Accessibility Construction Progress Observation Report #3 Final

The Cove

February 10, 2022

Terracon Project No. F8206002

#28 - Women's Restroom

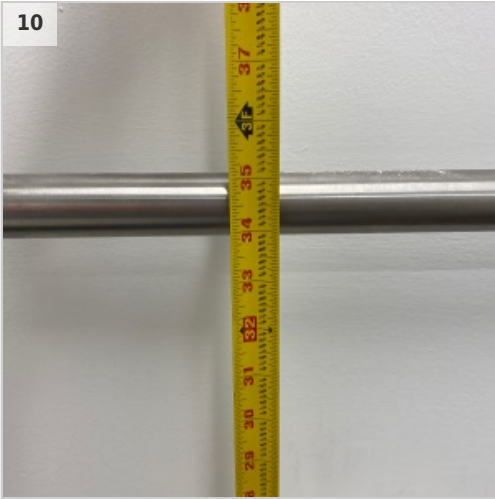
| Sahand Saljooghi | Issue: The paper tower dispenser is 54" above finish floor and should be lowered to a minimum of 48". | 02 Feb 09:21 AM |

● **#29 - Men's Restroom**

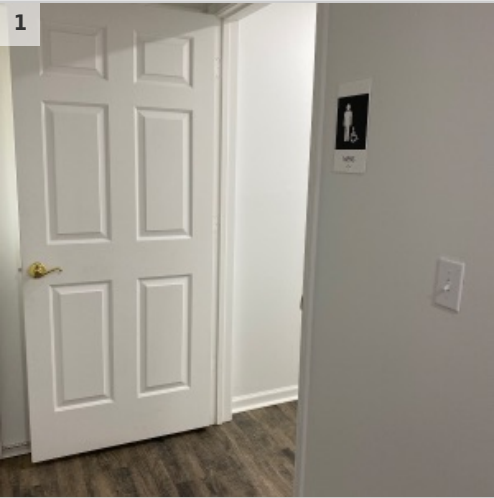
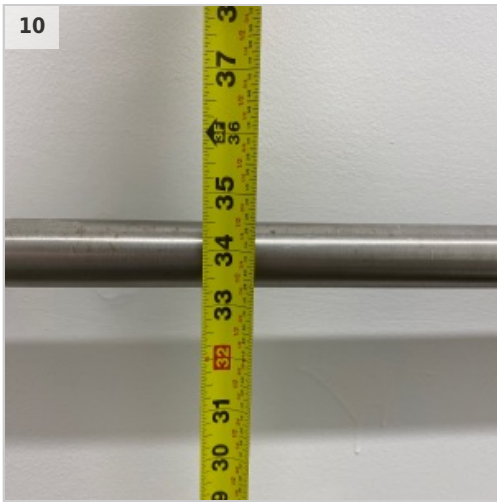
| Sahand Saljooghi | Issue: The paper tower dispenser is 54" above finish floor and should be lowered to a minimum of 48". | 02 Feb 09:09 AM |
